Product Change Notification - SYST-11ODFZ833

ERRATA - dsPIC33CH128MP508 Family Silicon Errata and Datasheet Clarification

Description of Change: Added silicon issue 31 (I2C).

dsPIC33CH128MP508 Family Silicon Errata and Data Sheet Clarification

FIGURE 1: I/O RAMP

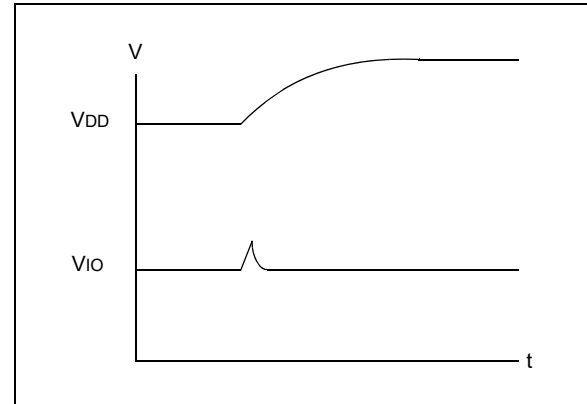
During a fast device power-up, when the V_{DD} ramp is less than 4 mS, the I/O pins may drive up to 100 μ A current for a duration of up to 10 μ S (Figure 1).

1. Slow down the V_{DD} ramp time (greater than 4 mS for V_{DD} to ramp 0V to 3.3V).
2. Ensure the circuitry that is connected to the pins can endure this pulse.

Example applications affected may include complementary power switches, where a transient current shoot-through might occur.

High-voltage applications with complementary switches should power the high-voltage 200 μ Sec later than powering the dsPIC[®] device to avoid the current shoot-through. This behavior is specific to each device and not affected by aging.
